# Crown Street upgrade

Community Meeting – Tuesday 28 February 2023

# **CROWN STREET, SURRY HILLS DEVONSHIRE ST TO OXFORD ST UPGRADE**

# Peer Review Aim

# Approach to the verge

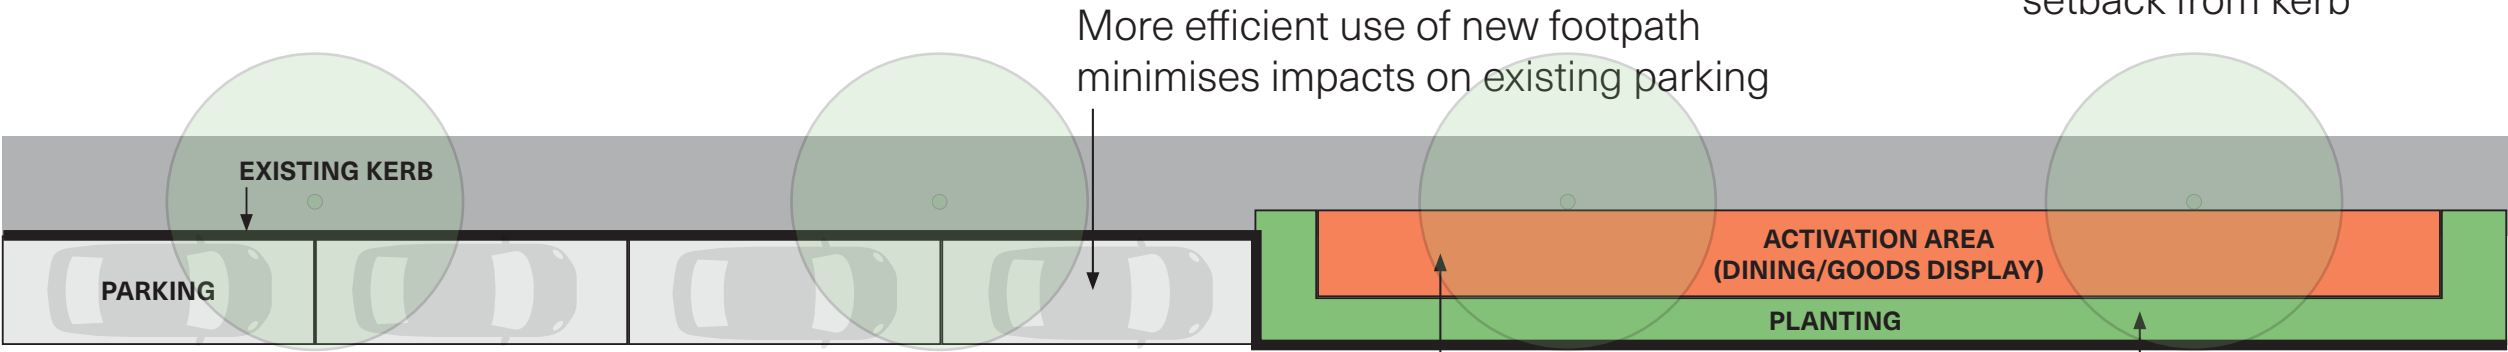
More efficient use of new footpath  
minimises impacts on existing parking

Activation Area  
setback from kerb

Creates longer flexible  
Activation Areas for outdoor  
dining and displaying goods

Provides more opportunities for  
greening and tree planting

# Typical verge proposals

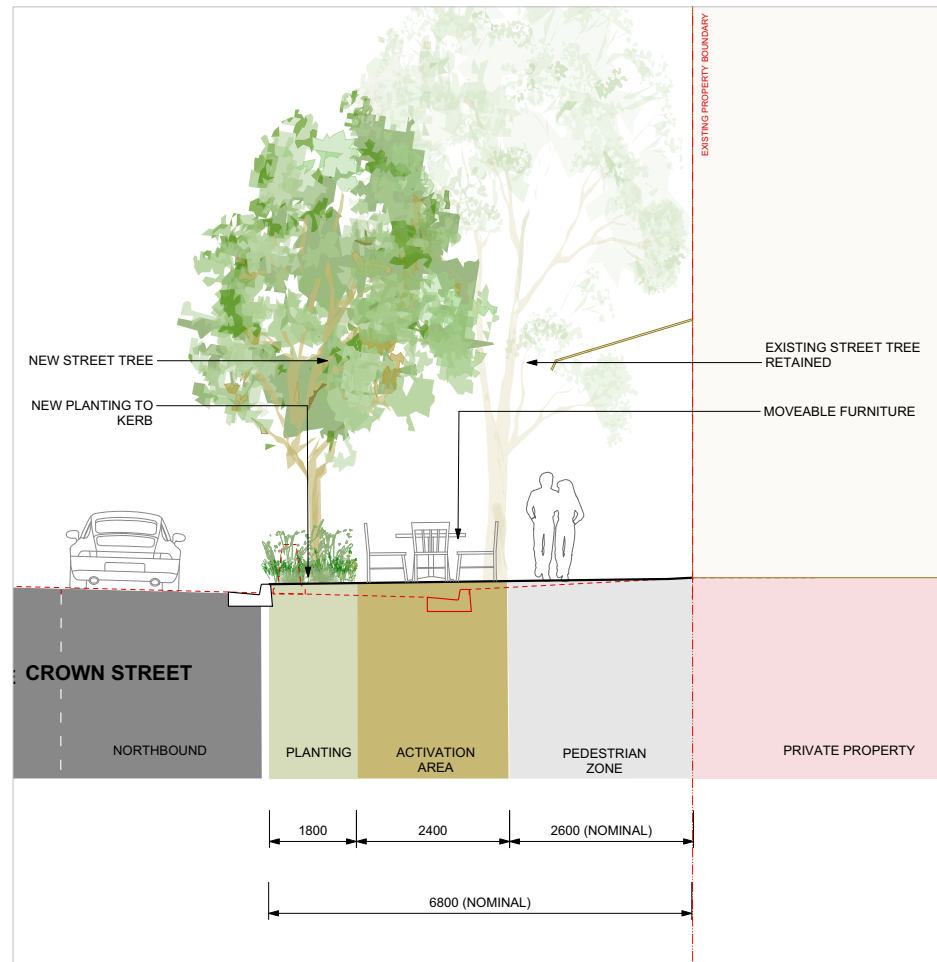
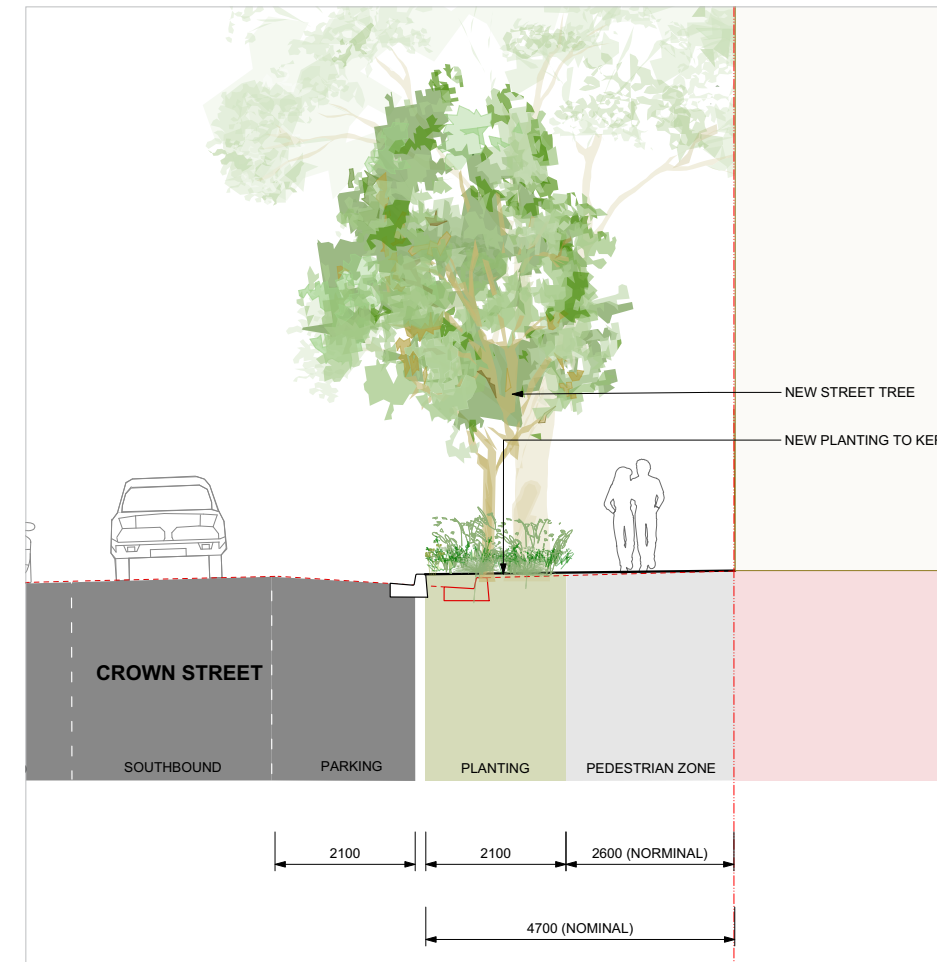
- Remove car parking
- Introduce Activation Area and new planting bed to back-of-kerb
- Widen footpath against building edge

- Narrow car parking lane
- Introduce new planting bed to back-of-kerb
- Widen footpath against building edge

# Peer Review Concept Design

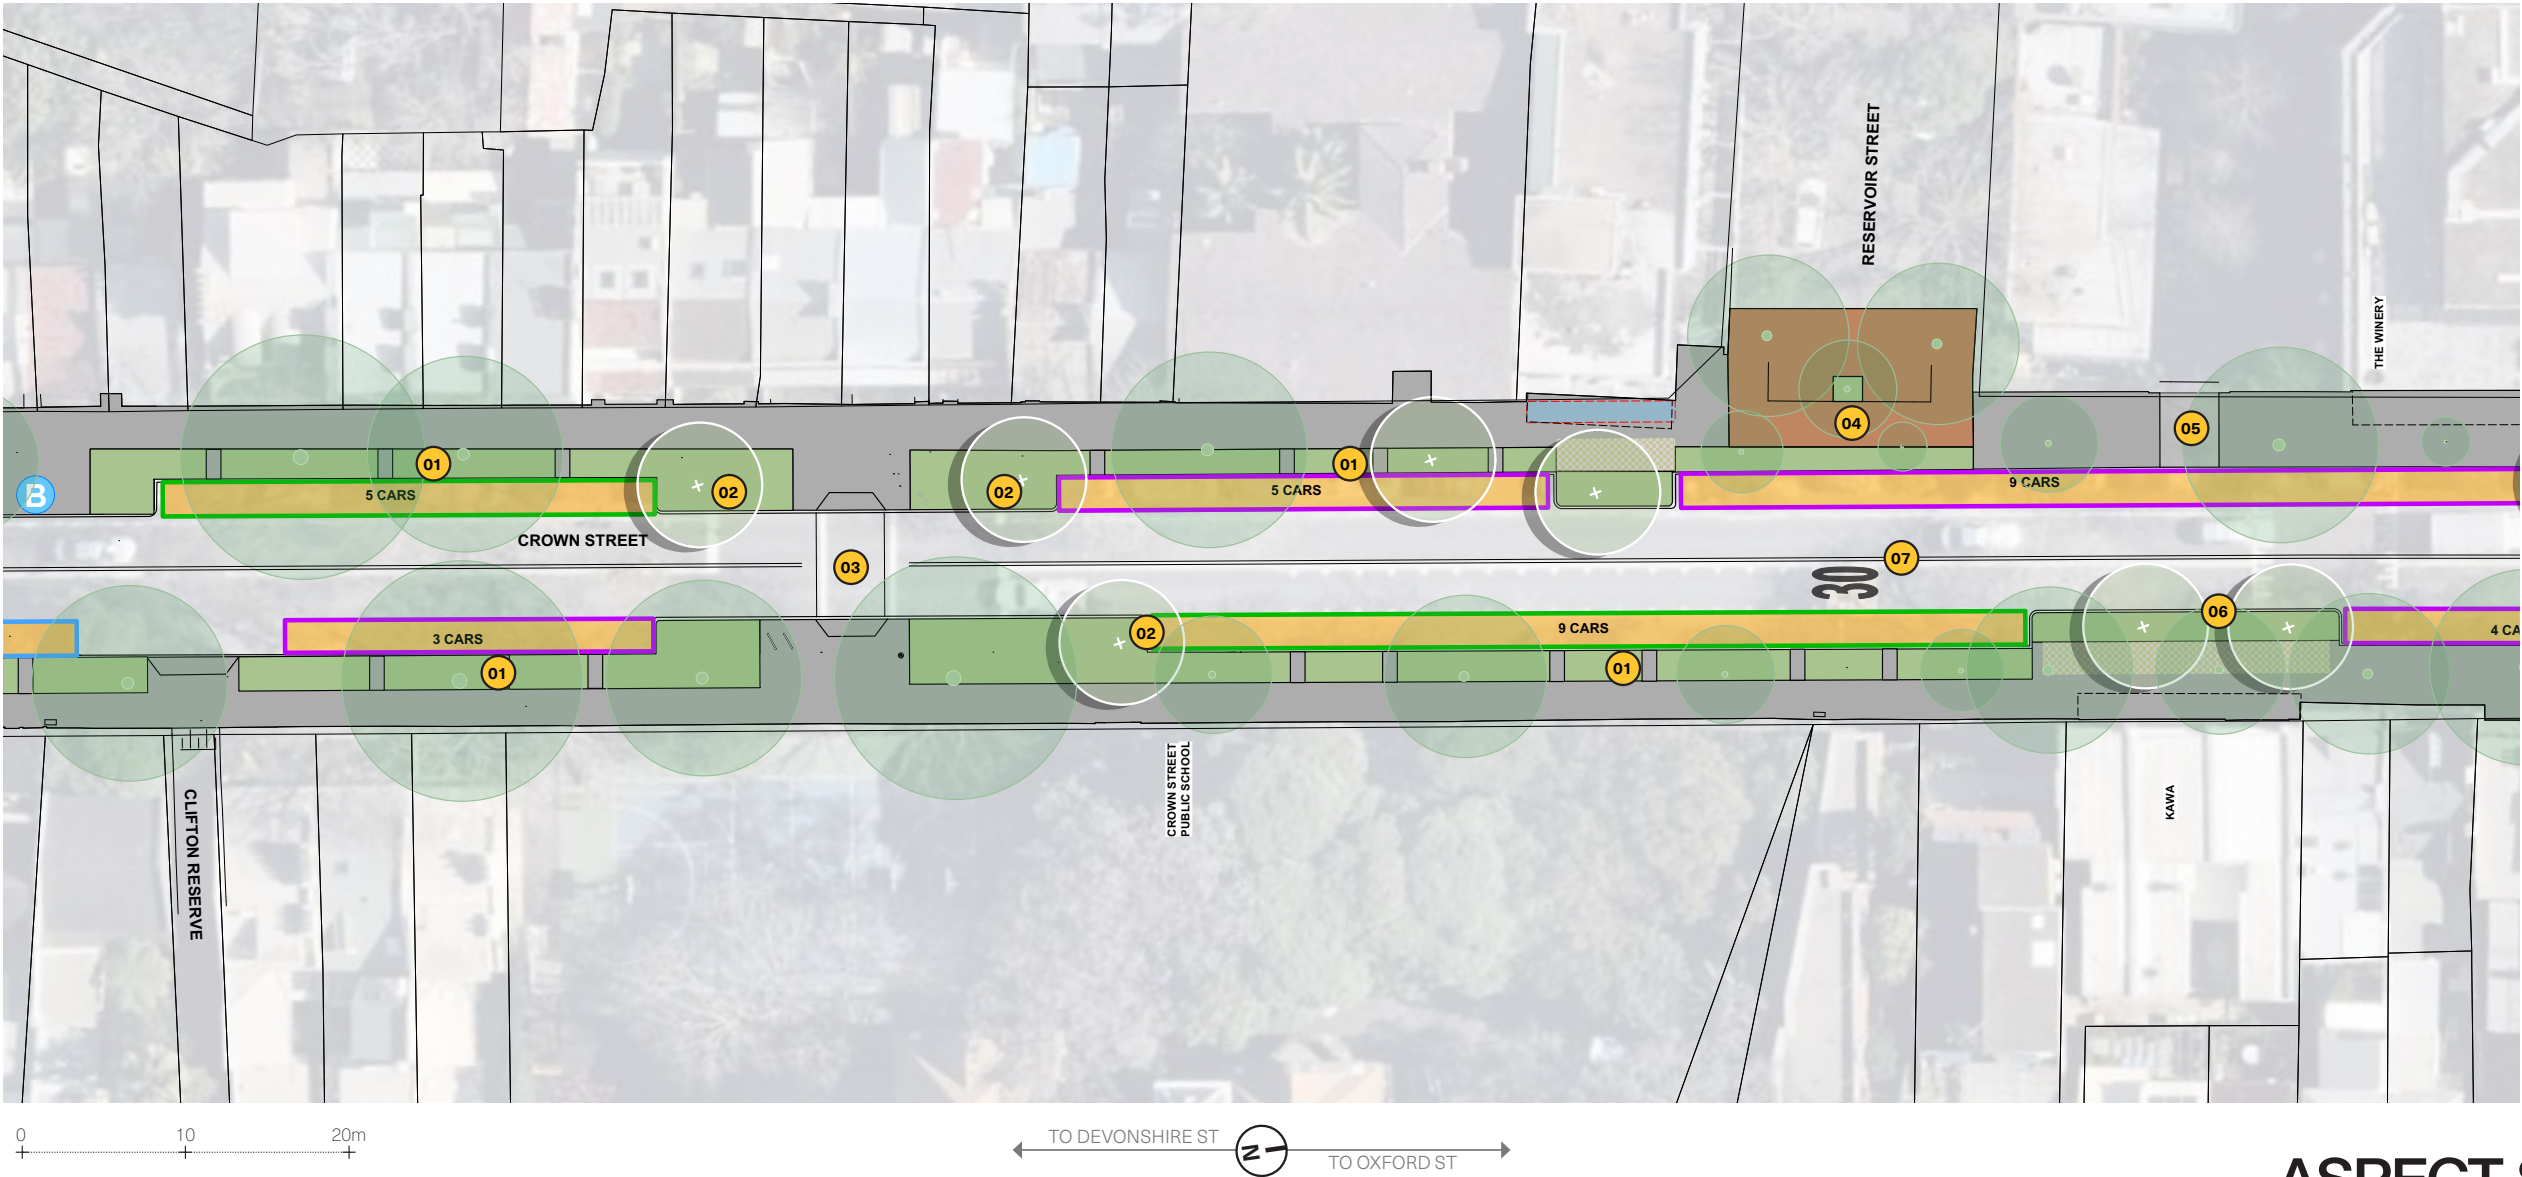
Kerb alignment adjusted (to minimum compliant parking space width) to maximise footpath and planting space. Continuous planting bed provided with intermittent pavements for access to parked vehicles.
2.

New kerb extension with planting and street trees to provide additional canopy cover.
3.

Existing signalised crossing retained in current location.
4.

Existing brick paving to full width of Reservoir St lot boundary to be retained.
5.

Existing heritage driveway retained.
6.

New kerb extension to create activation area with kerbside planting and additional street trees at existing commercial premises.
7.

Speed reduction to Crown Street to 30km/h (subject to TfNSW approval).

# Peer Review Concept Design

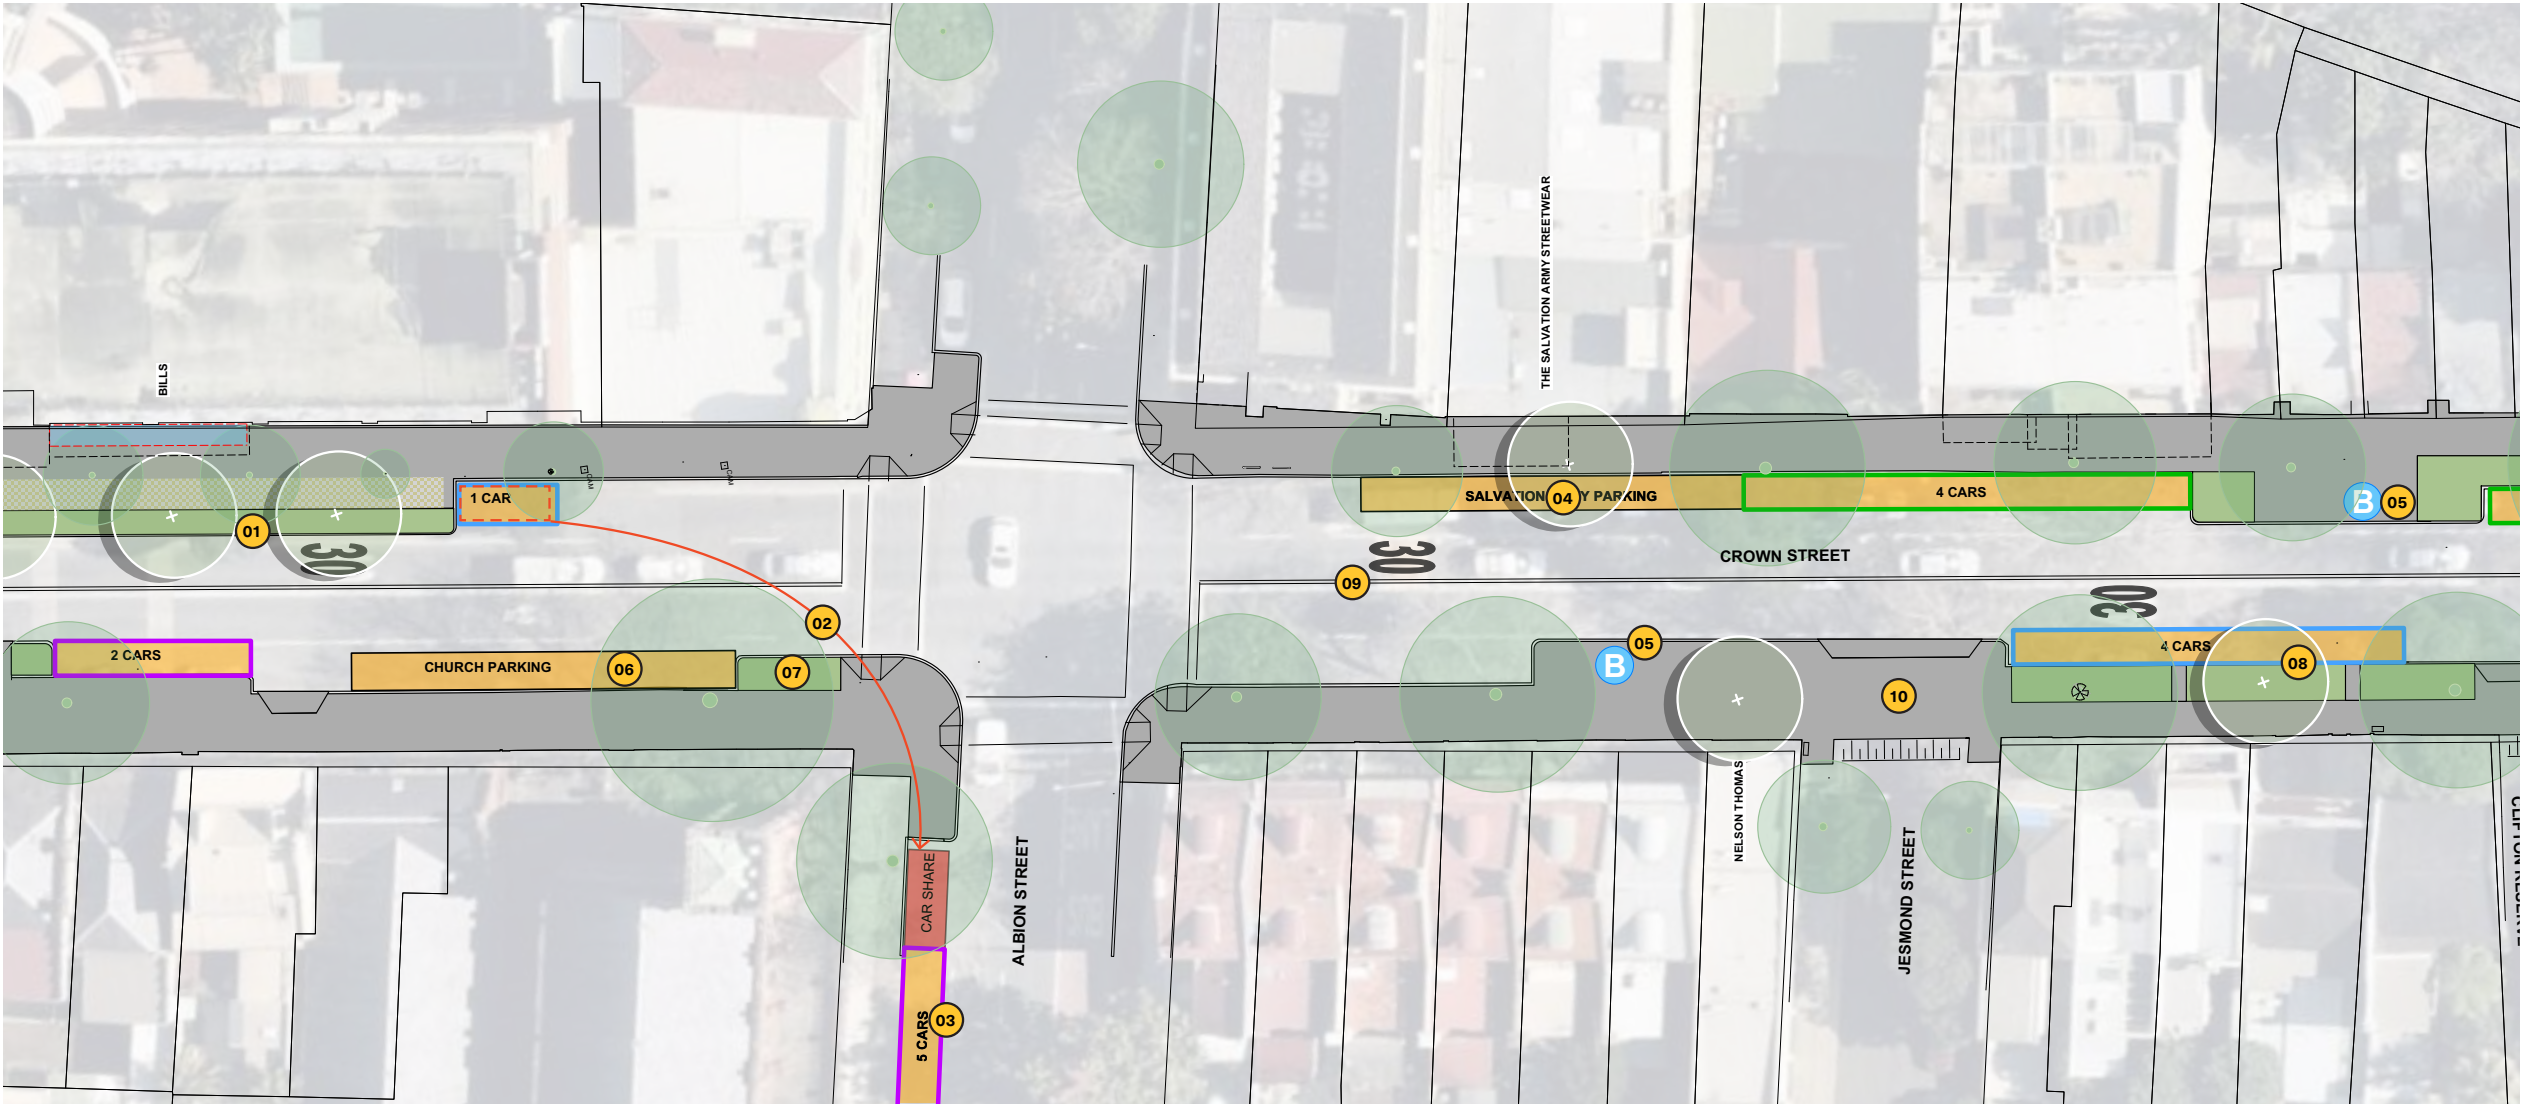
New kerb extension to create activation area with kerbside planting and additional street trees at existing commercial premises.
2.

1x car share relocated to Albion St, replaced with 2P parking space.
3.

Convert 6 no. existing unmarked 2P parking spaces on Albion St to 5 no. marked 2P parking spaces.
4.

Existing Salvation Army parking area. Investigate opportunity to introduce Loading Zone and/or after-hours general parking (subject to further consultation).
5.

New kerb extension for in-lane bus stop, 9m paving zone shown, to be reviewed at detailed design stage to consider user access requirements (subject to approval by TfNSW).
6.

Existing signed church parking area. Investigate opportunity to introduce timed after-hours general parking (subject to further consultation).
7.

Kerb extension to provide additional pedestrian paving and planting at intersection.
8.

Kerb alignment adjusted (to minimum compliant parking space width) to maximise footpath and planting space. Continuous planting bed provided with intermittent pavements for access to parked vehicles.
9.

Speed reduction to Crown Street to 30km/h (subject to TfNSW approval).
10.

Continuous footpath treatment and kerb extension at Jesmond St.
